Proposed Sub-basin Drainage

The following is a description of the offsite and onsite basins, offsite bypass flows and the overall future drainage characteristics for the development of Sterling Ranch Filing No. 2. Ponds W4 and W5 are sized for the ultimate development, therefore, future developments have been included. As the future sites develop, final drainage reports will be completed to confirm the assumptions made in this report. Calculations have been provided to show the proposed storm infrastructure will adequately convey flows in the ultimate condition. The following basins parameters and developed runoff were determined using the Rational Method. Surface flow is designated as design points with whole numbers (1) and storm sewer routing as design points with decimals (1.0). See Appendix B for all Rational Method calculations and storm water routing.

Scenario: 100-YEAR
Current Time Step: 0.000 h
FlexTable: Conduit Table

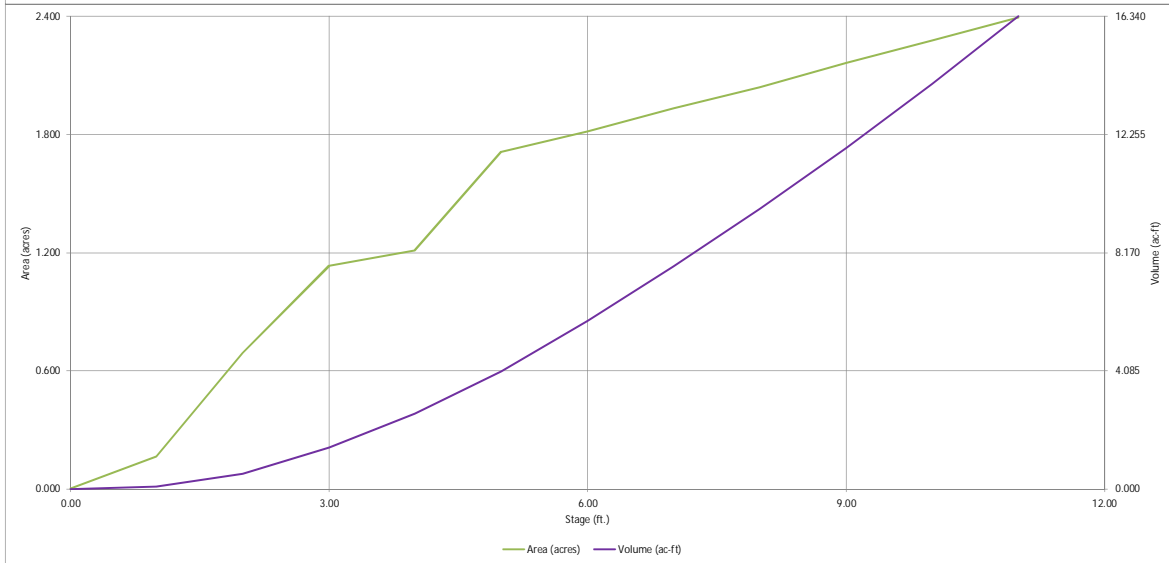
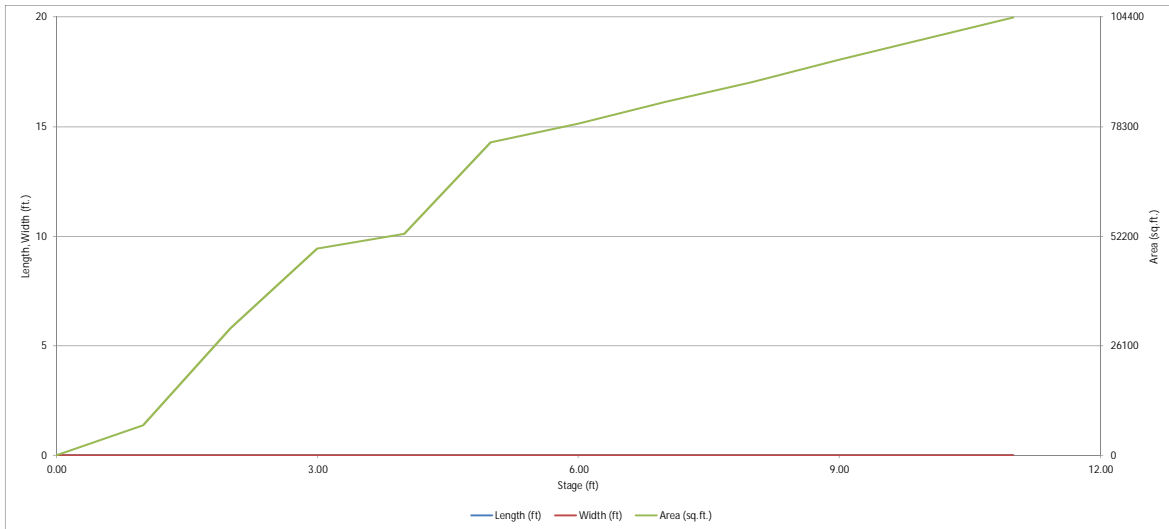
This is too high
